**ADDENDUM TO RFP DOCUMENTS**

<b>SOLANO</b> COMMUNITY COLLEGE 	ADDENDUM #01
	Project: #16-015 Solano Community College District Site Lighting Improvements Project
	Date: March 29, 2016

**ITEM NO. 1 – PLAN SHEET 0.00 – COVER SHEET, INDEX**

SHEET  
EL101

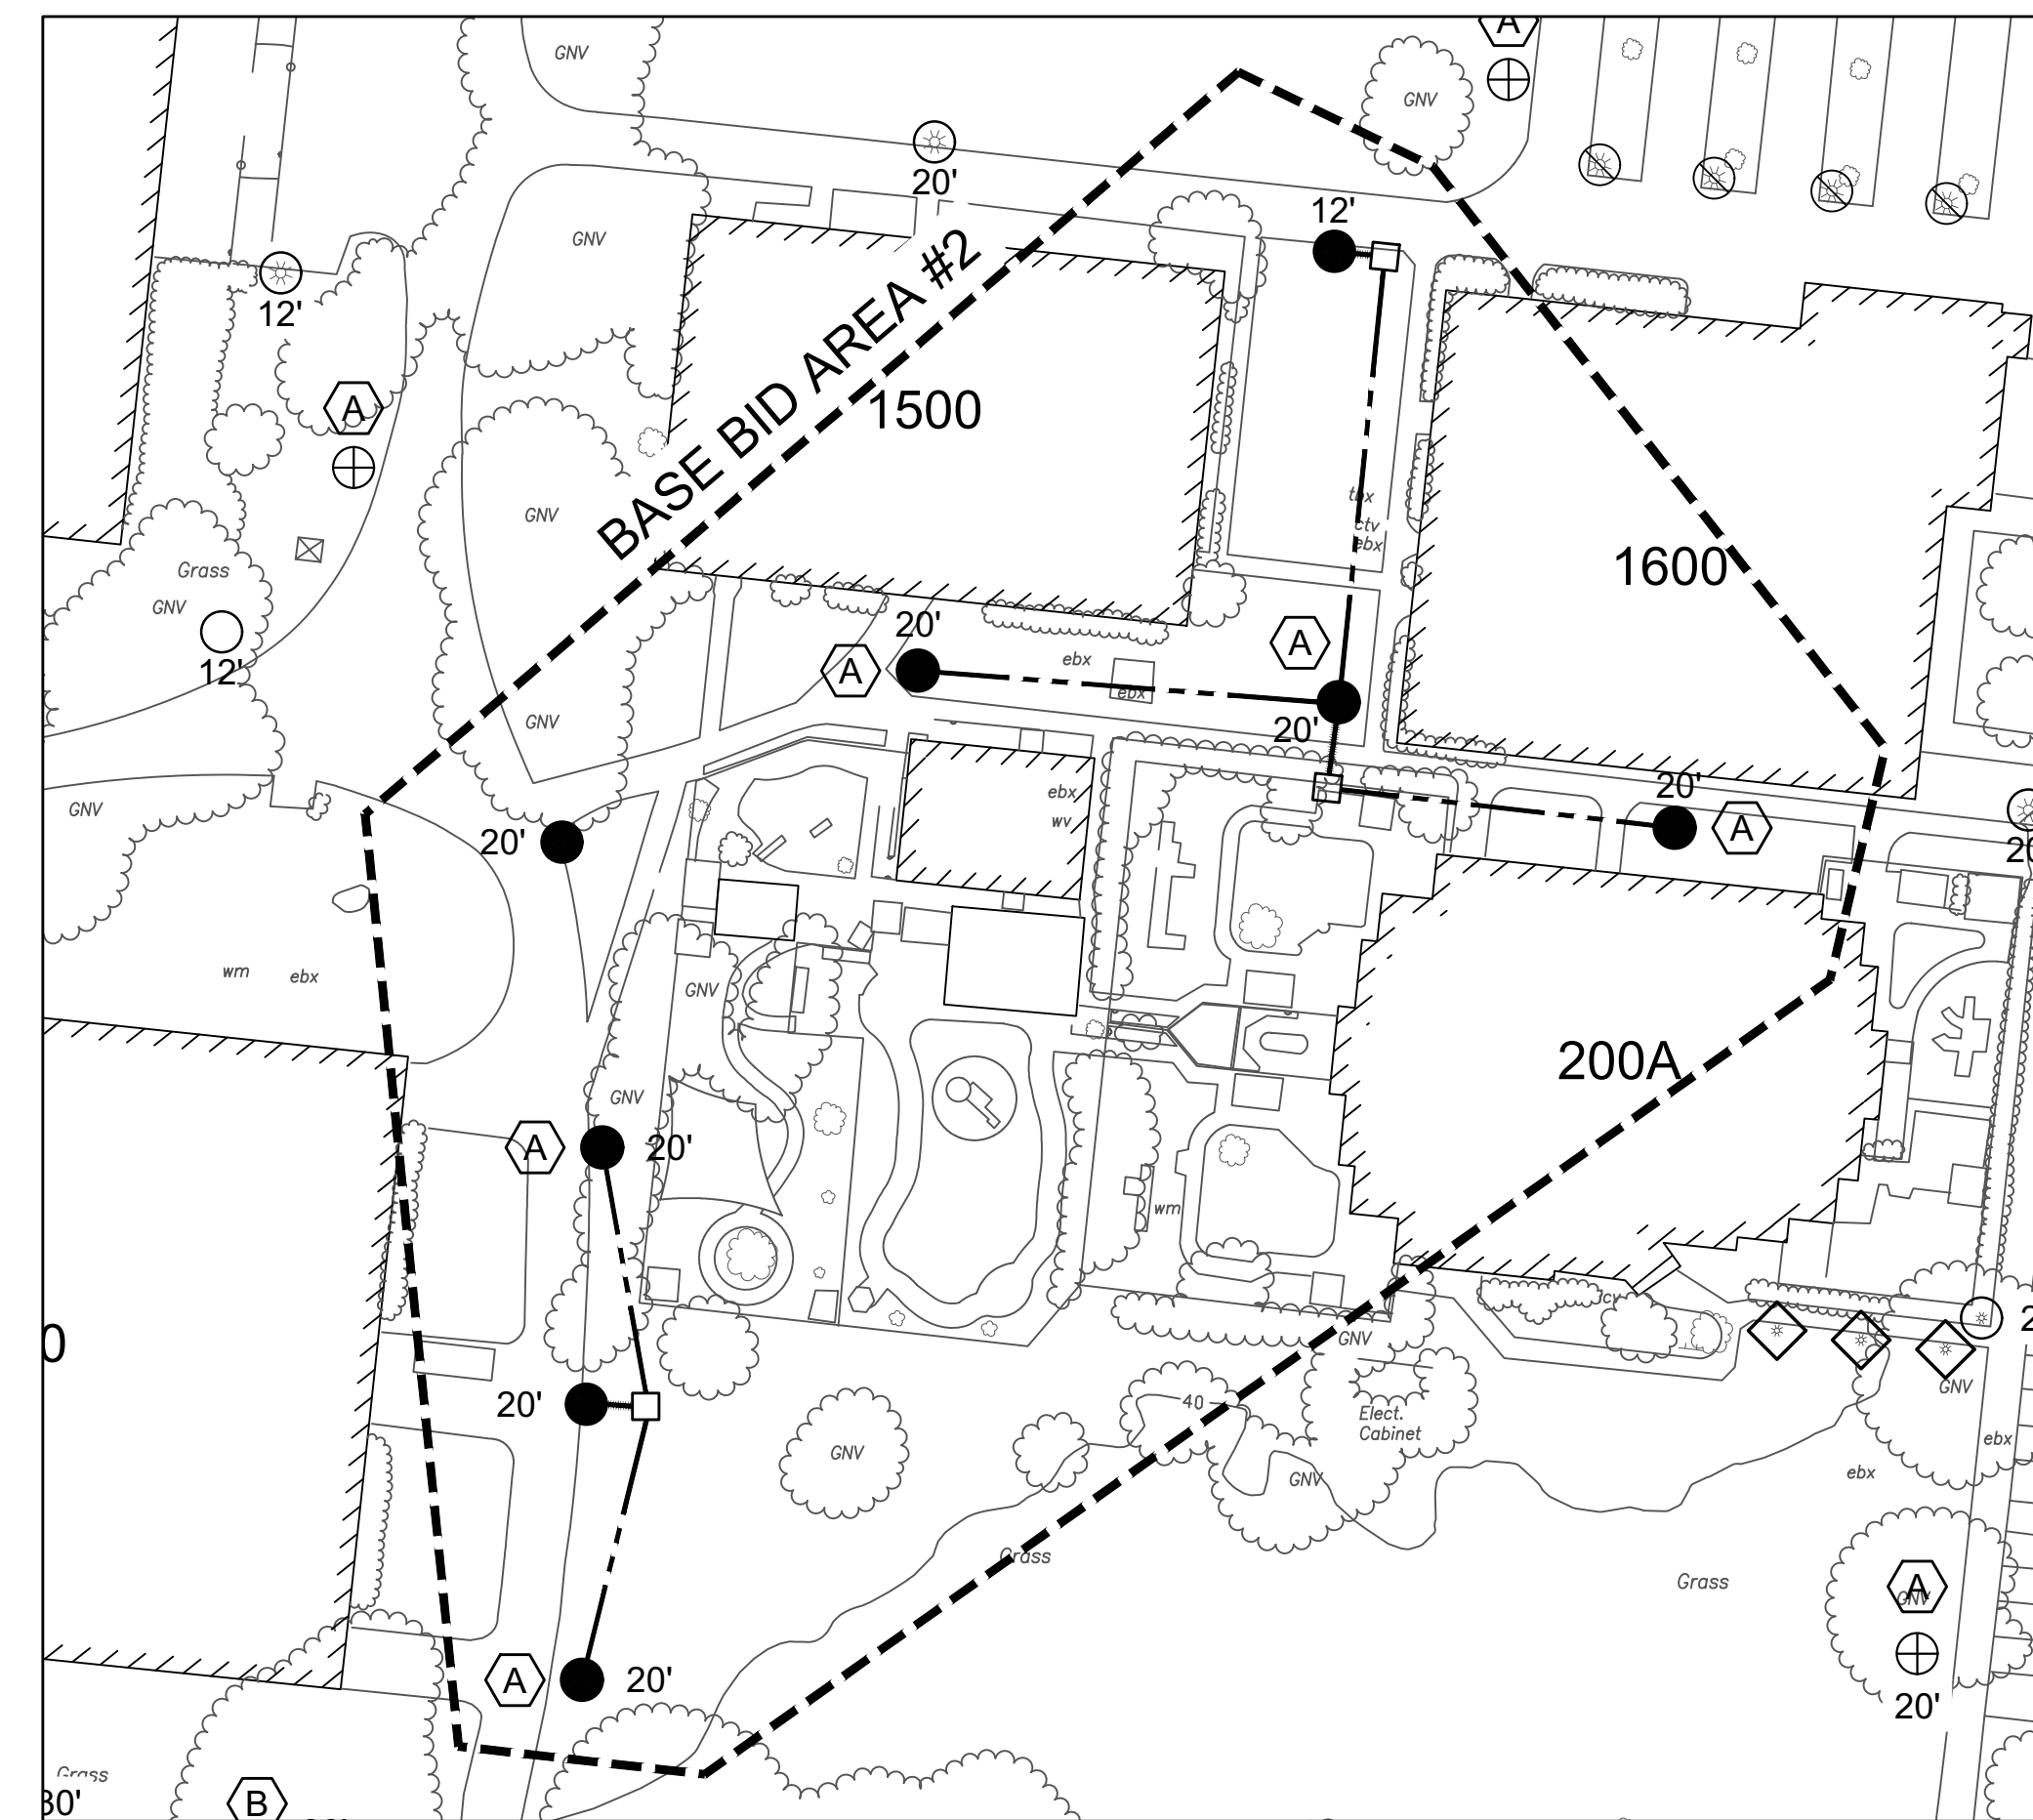
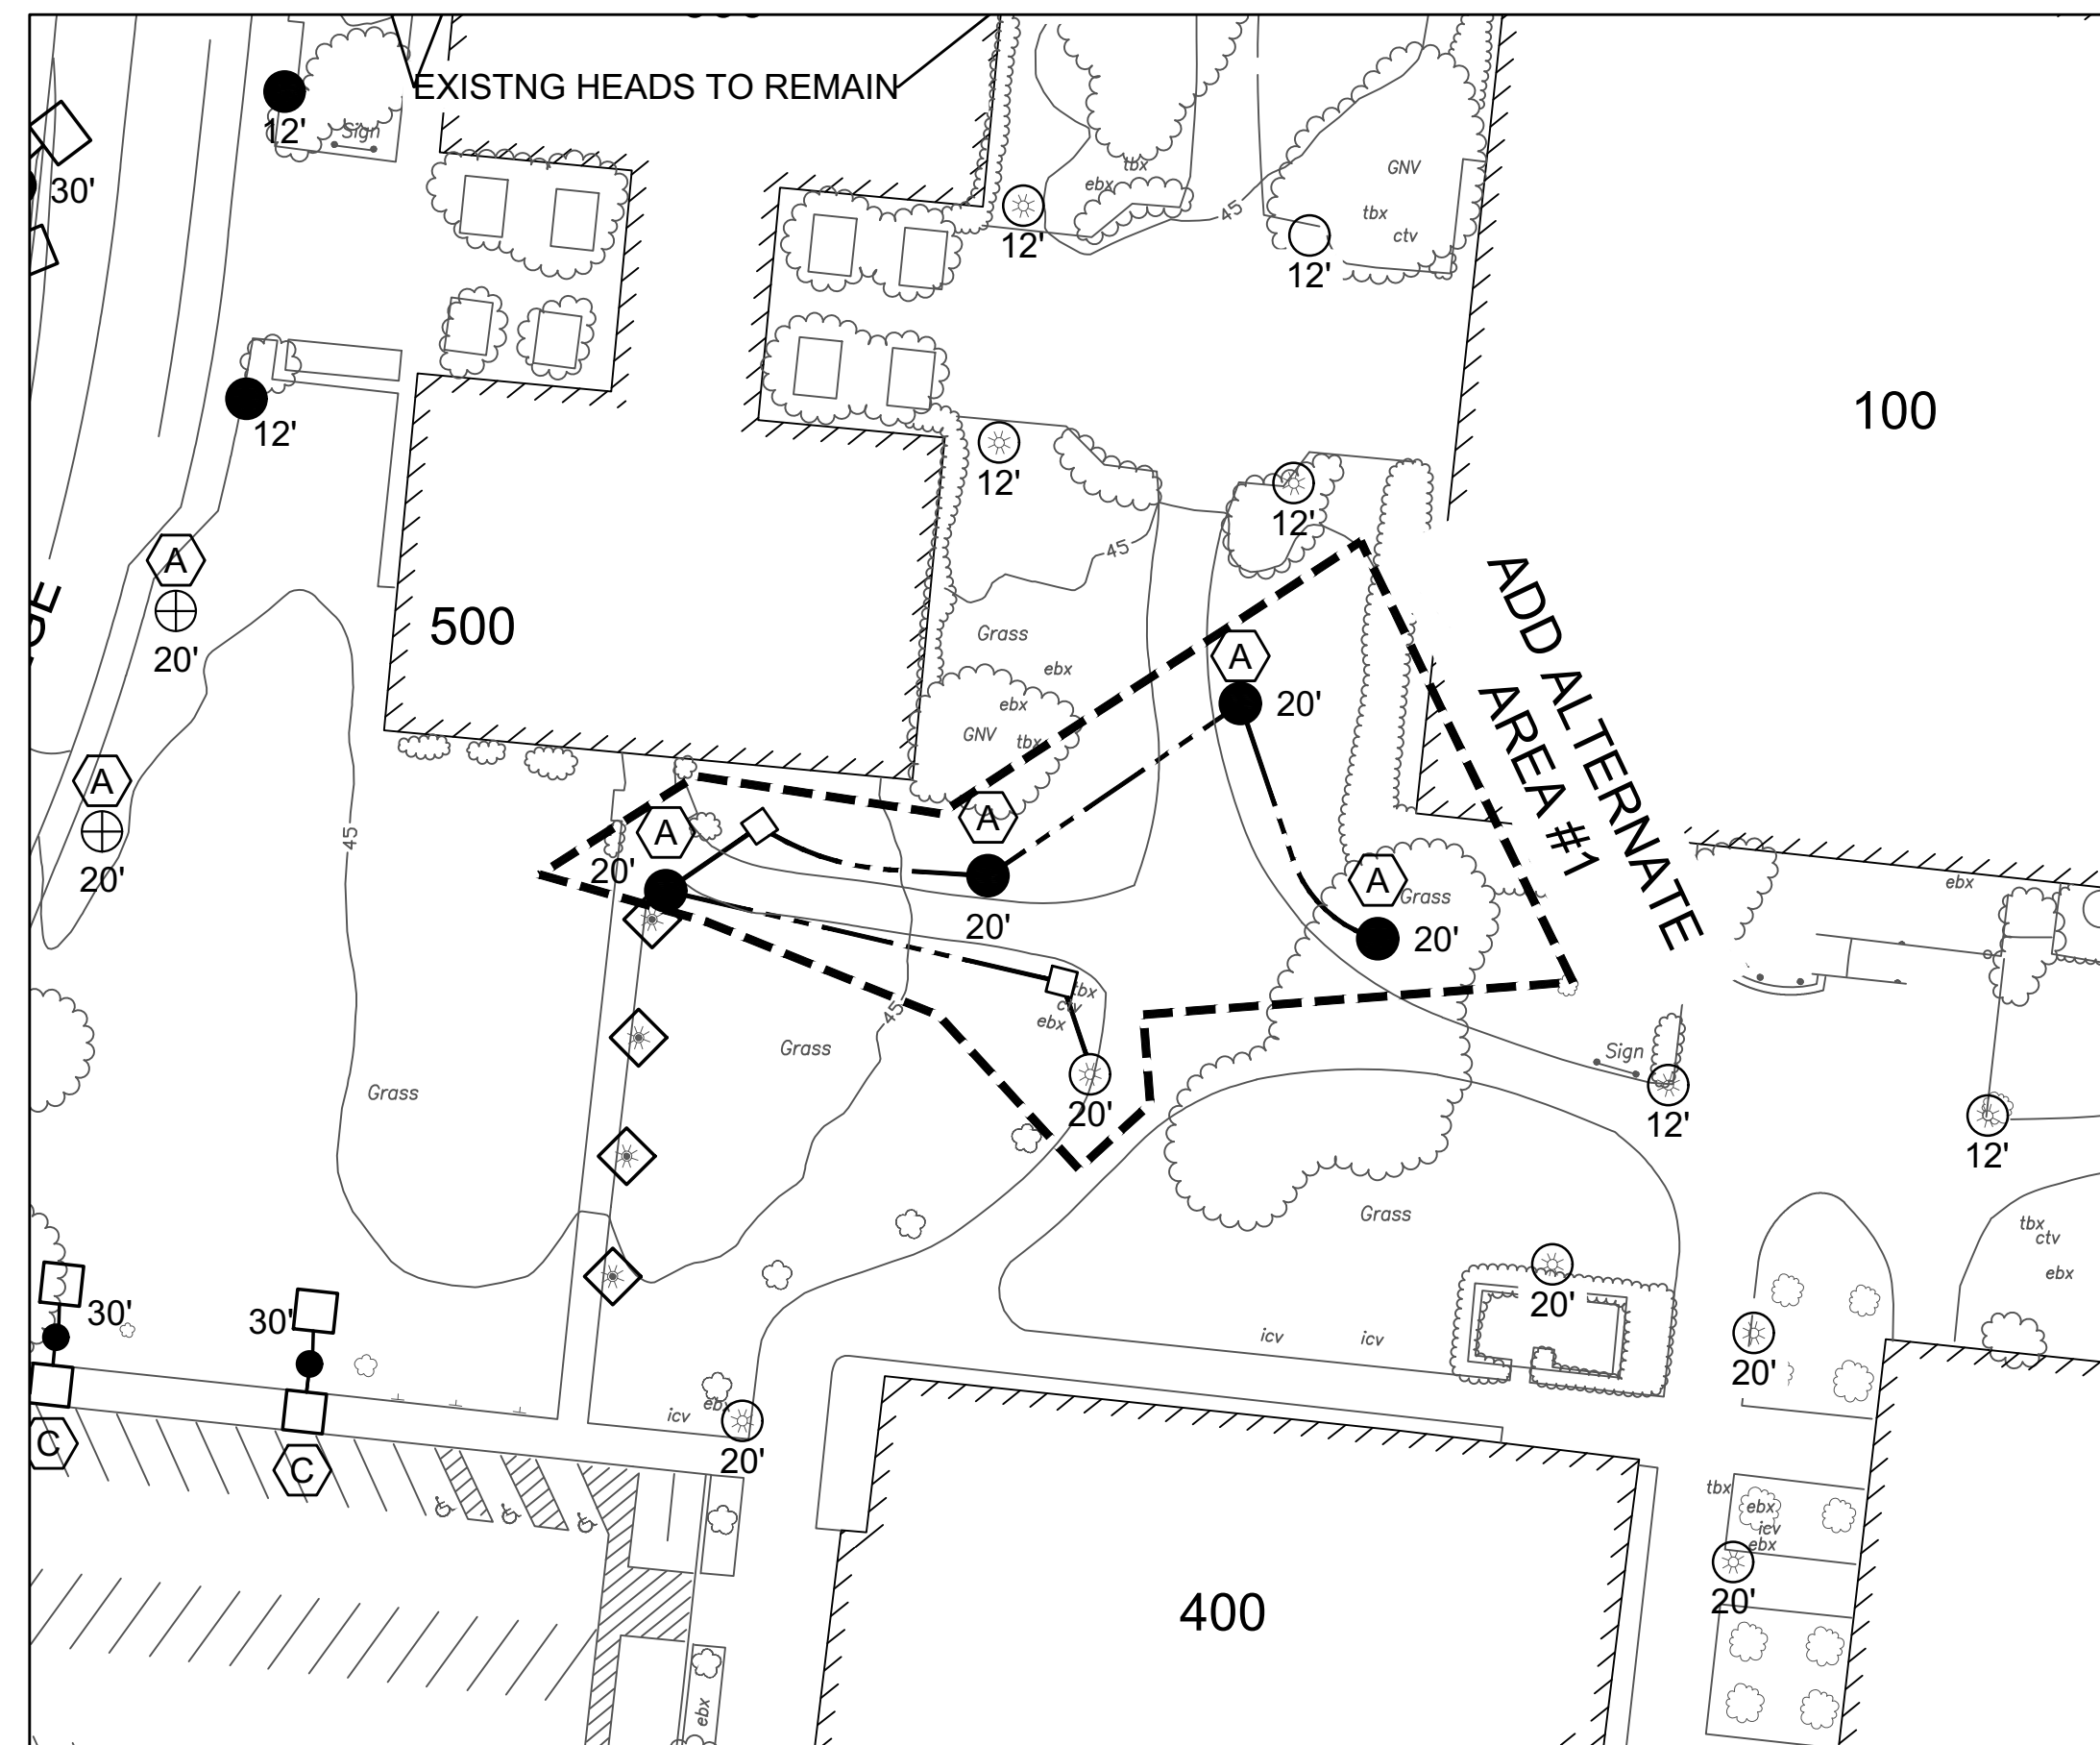
**ITEM NO. 3 – PLAN SHEET EL 101 – ENLARGED PLAN BASE BID AREAS #1 & #2 & ADD ALTERNATE AREAS #1 & #2**

Replace ‘Plan Sheet EL 101’ with attached revised ‘Issue for Addendum #1 3/30/16 – Plan Sheet EL 101’. Revisions include the following:

- Delete Fixture Types ‘B’ and ‘C’ from ‘Light Fixture Schedule’.
